Agenda Item # 5

BOA-003542-2025

- Fence Variance to allow an eight-foot (8') tall fence within the required front yard setback in an R-1, Single-Family Residential Suburban District.

APPLICATION NUMBER	6719	DATE	December 1, 2025
APPLICANT	Catherine Clark, Agent		
REQUEST	Fence Variance

SITE PLAN

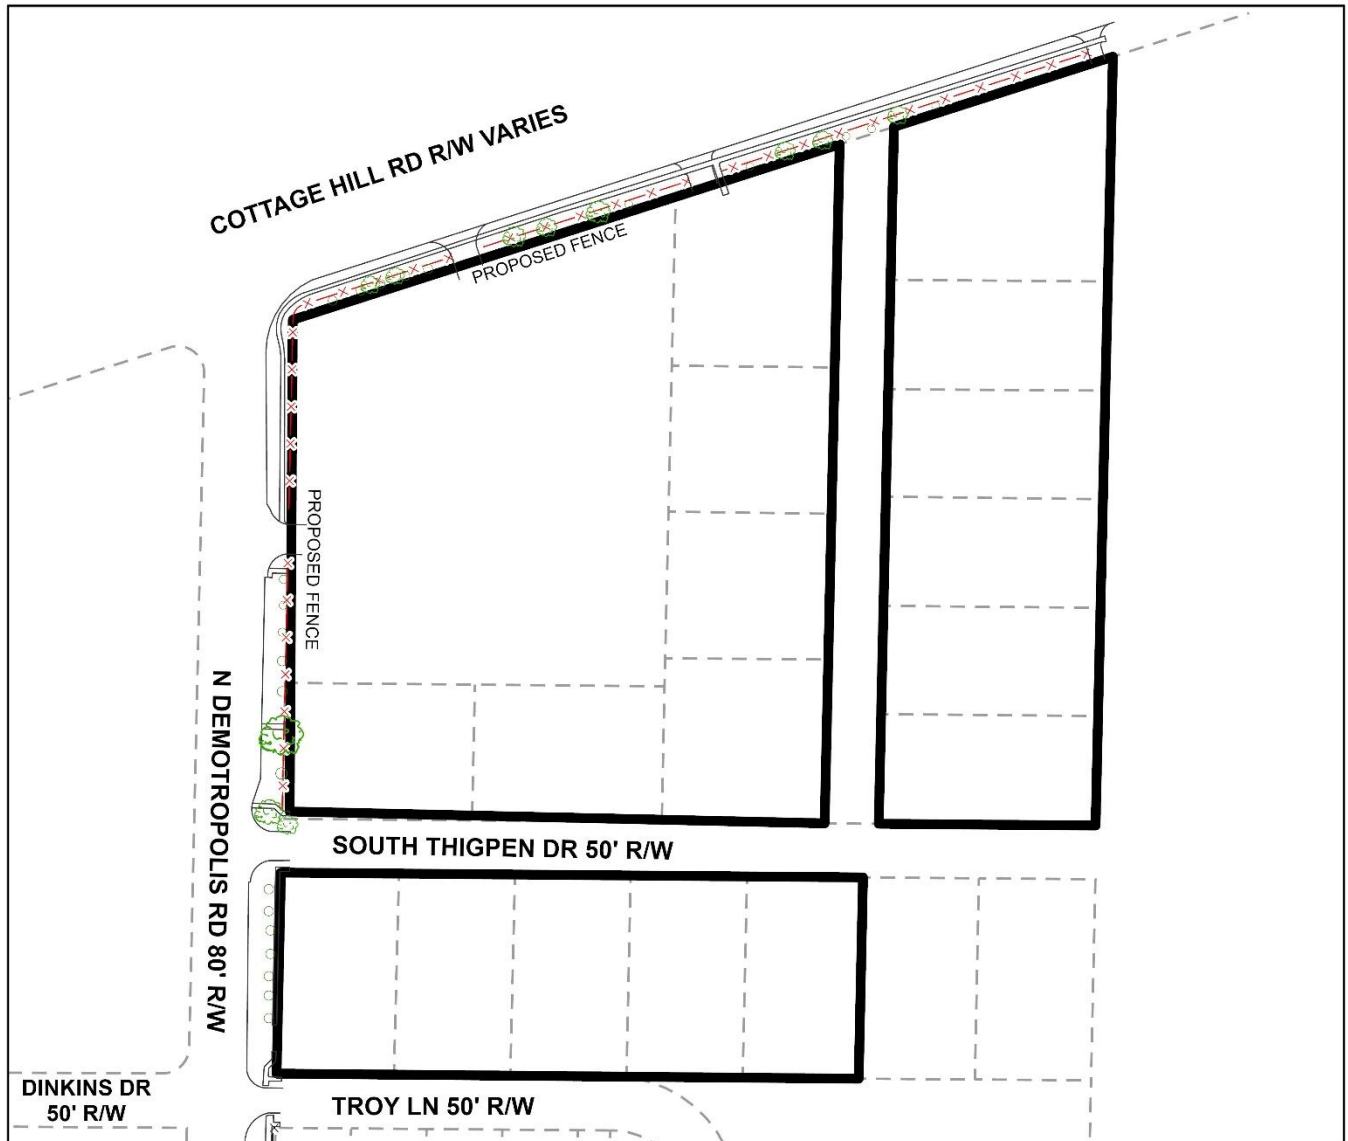
The fence and brick columns including the footers must be located on private property not in the Public Right of Way.

The proposed fence within the right-of-way along Cottage Hill Road would prevent traffic signal maintenance and would negatively impact sight distance at the intersection of Cottage Hill Road and North Demetropolis Road. Additionally, it would obstruct the maintenance and installation of utilities. The proposed fence along North Demetropolis Road would also negatively impact the sight distance at the intersection of North Demetropolis Road and Troy Lane.

While it is understandable that the applicant wishes to better secure their property, the proposed wall has the potential to cause line-of-sight issues for traffic at the intersections of Cottage Hill Road and North Demetropolis Road.

- 1) Acquisition of all necessary permits for the construction of the fence.
